9 March 2026

OSS Comment on Planning Application PL/2026/00168

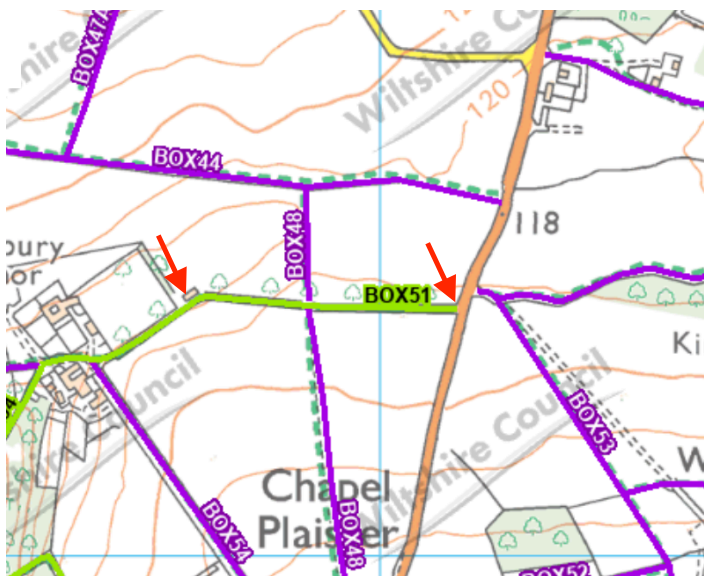
At present, the northern access (Bridleway BOX 51) is used for 2 way agricultural traffic between the Bradford Road and the barn/field-access gap shown in this snapshot:

Will this two way agricultural access on BOX 51 continue if the planning application is approved, or will agricultural traffic also have to follow the one-way circuit? Or will agricultural access stop altogether on the circuit, and use a different access/egress point to the field and barn?

If the 2 way agricultural access between the barn and the Bradford Road continues, then the additional hotel traffic will increase the overall use by vehicles of the bridleway compared with now. Speed control measures and passing bays suitable for mounted riders will be necessary for the increased hotel traffic alone, and more so if 2 way agricultural access continues along the bridleway.

If the agricultural access is to follow the one way circuit, then the part of BOX 51 between BOX 54 and the barn, which is narrow and constrained by walls and fencing, will become very dangerous for mounted riders. We believe this should not be permitted. Even without agricultural traffic there, passing bays for mounted riders will be necessary in this narrow section.
